# CITY OF PORTLAND, MAINE

Project Name: 58 Fore Street Master Development Plan Application  
Project ID: 2016-224  
Address: 58 Fore Street CBL: 018 A001, 018 A002, 018 A003  
Applicant: CPB2, LLC  
Planner: Christine Grimando

## PLANNING BOARD REPORT PORTLAND, MAINE

58 Fore Street  
Master Development Plan  
Project #: 2016-224  
CPB2

ATT. 1

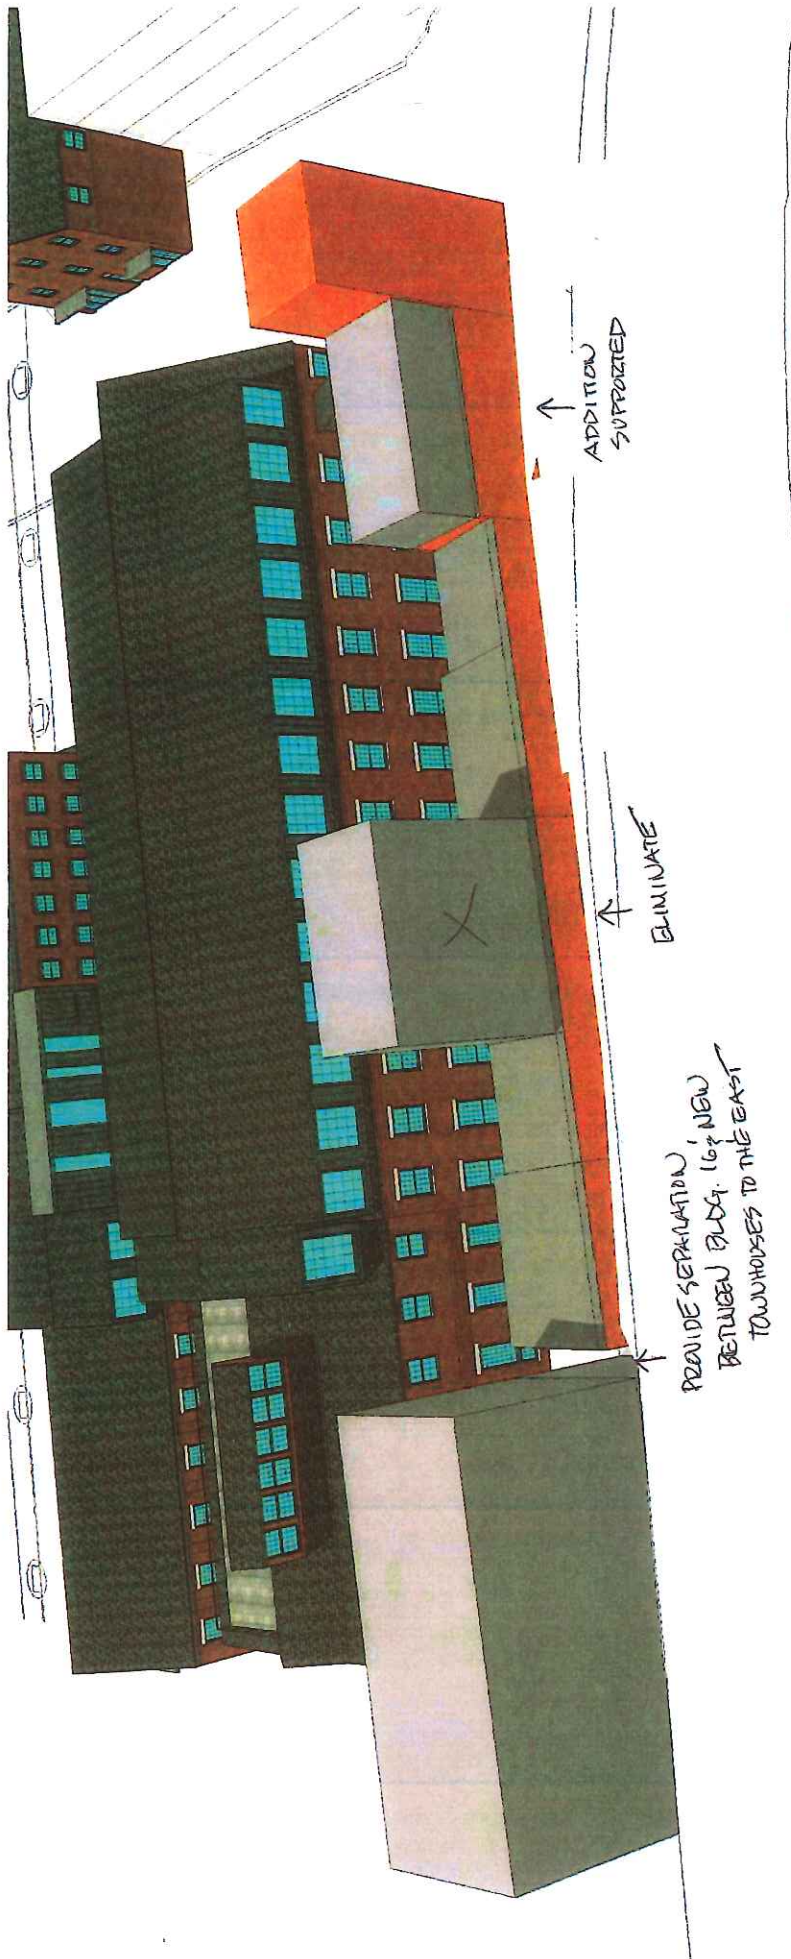
- 1) The Board voted 6-0 (Sheridan recused) that on the basis of plans, elevations and renderings of proposed development included in the Master Development Plan for 58 Fore Street and information included in the staff report for the December 7, 2016 public hearing, the Board finds that the proposed Master Development Plan for 58 Fore Street, specifically that portion of proposed development located within the boundary of the Portland Company Historic District, is in conformance with Portland's Historic Preservation Ordinance standards **subject to the removal of the proposed rooftop addition above Building 16, the reduction in scale of proposed infill construction on the footprint of Buildings 14 and 15 to a height not to exceed existing building heights, and the provision of an offset separating Building 16 and new townhouses to the east.** (See ATTACHMENTS 1 AND 2.)

1. Marked-up axonometric view from 9/12/16 Master Development Plan showing additions and proposed infill construction required to be removed to satisfy historic preservation ordinance standards.
2. Marked up 12/2/16 axonometric view showing same.
3. 11/10/16 letter (with attached map) from Mary Costigan of Bernstein Shur requesting boundary amendment to Portland Company Historic District

Figure 8, Average Grade Calculations

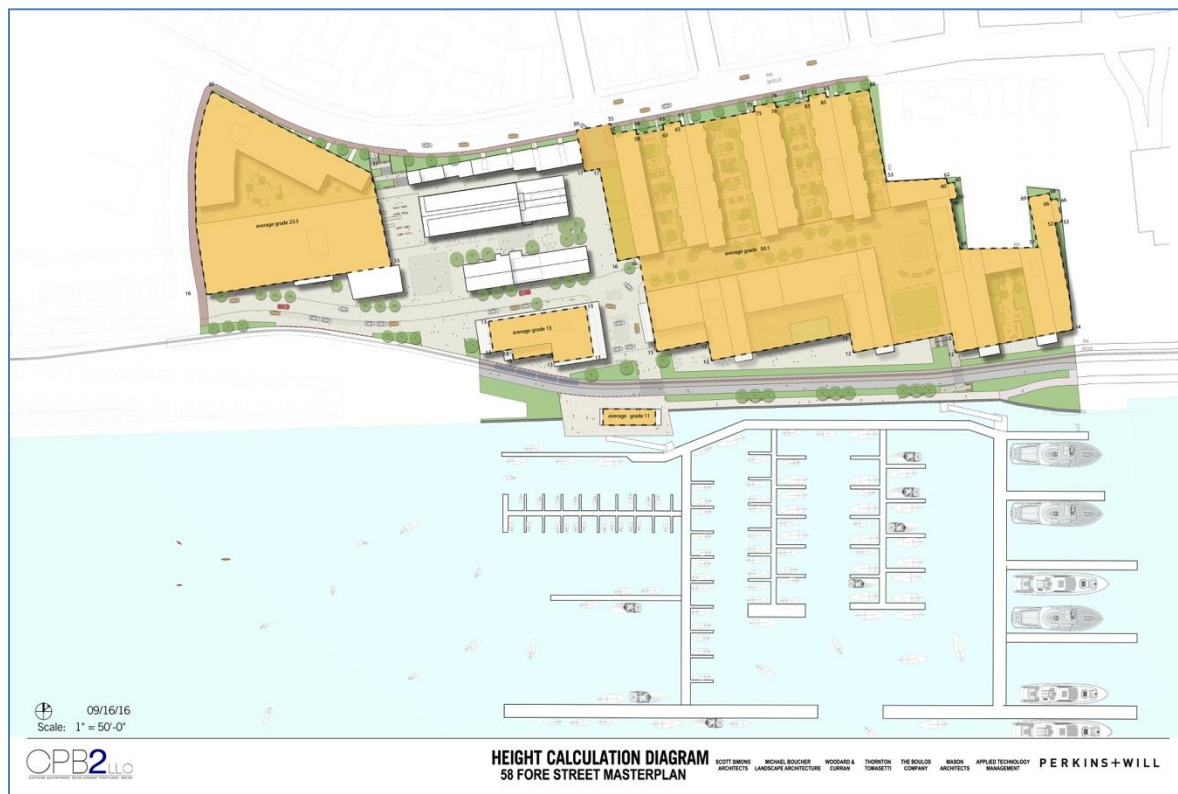
Ann Machado, the City’s Zoning Administrator has confirmed that there are two acceptable methods for establishing average grade (Attachment XIV): averaging the elevation of the proposed abutting ground surface at the building corners, or by averaging the elevation of the abutting ground surface at consistent intervals around the perimeter of the building. The applicant is proposing a single building on the eastern portion of the site that has pedestal parking at the base, with connected and architecturally varied residential uses above. Attachment G includes the applicant’s calculations of average grade for each building proposed, which the Zoning Administrator has confirmed. She also states that if the parking base is built in phases, the average grade for each phase each phase will need to be evaluated for consistency with the B-6 Height Overlay. There are no final building designs in a MDP plan application, so this review addresses the feasibility of the site design concept as proposed.

The plan as shown in the Overall Site Masterplan and in the Height Calculation Diagram (Figures 1 & 8) is consistent with the definition of building height in Chapter 14, the allowed heights in the B6 Height Overlay, and established methodology. View corridors and the break in massing have been adhered to. All final building designs will be reviewed for compliance with the Height Overlay and other applicable sections of Chapter 14 over the course of Site Plan Review.
